INFORMATION LETTER 002

TITLE: Low fuel pressure indication on Sling aircraft fitted with Rotax 912 ULS engine.

MODELS AFFECTED: All Sling LSA and Sling 2 aircraft fitted with Rotax 912 ULS engines.

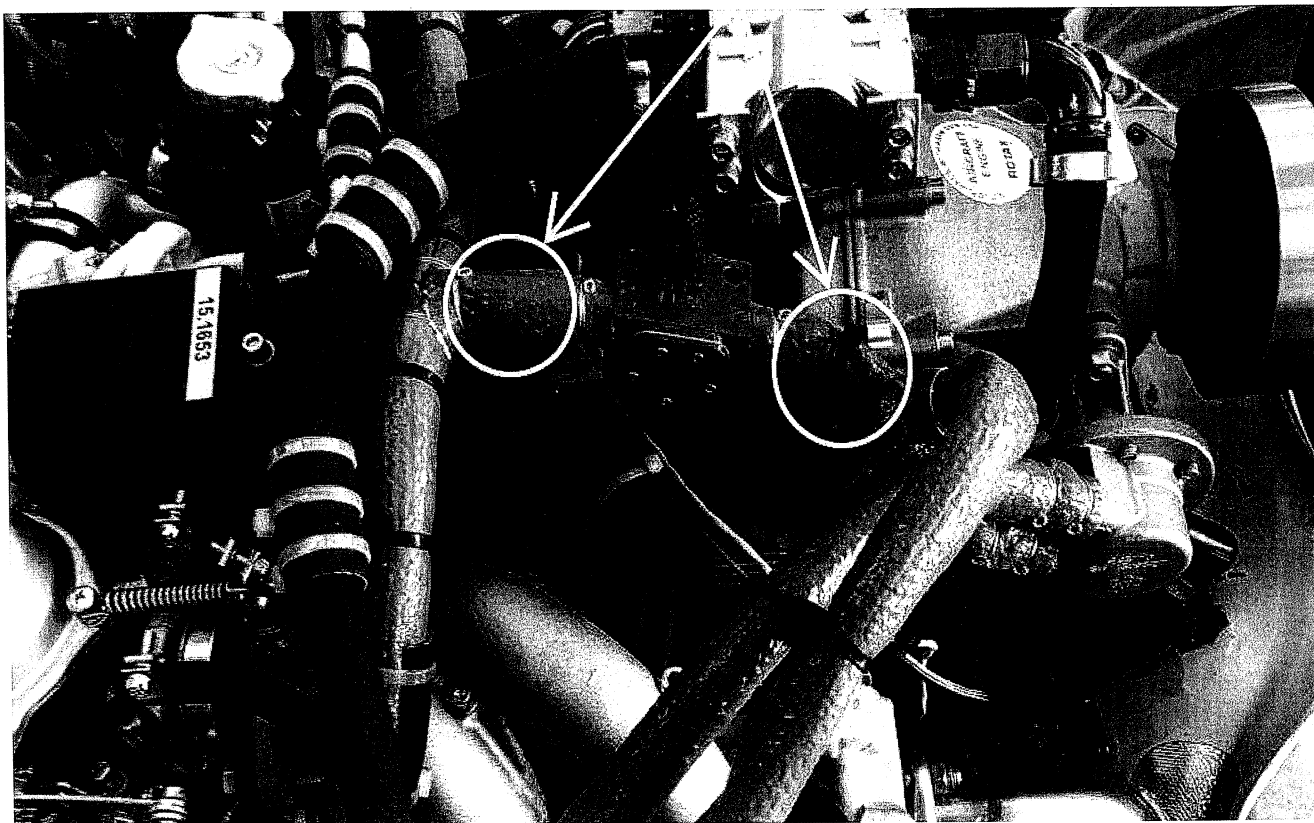
RECOMMENDATION: Fitting 2 fuel filters in the fuel line helps reduce pulsing in the fuel lines. The result is stable and correct fuel pressure readings.

Install the fuel filters on both sides of the fuel pressure transducer (see photographs) and cover with fire sleeve.

Position for installation of Fuel Filters as shown
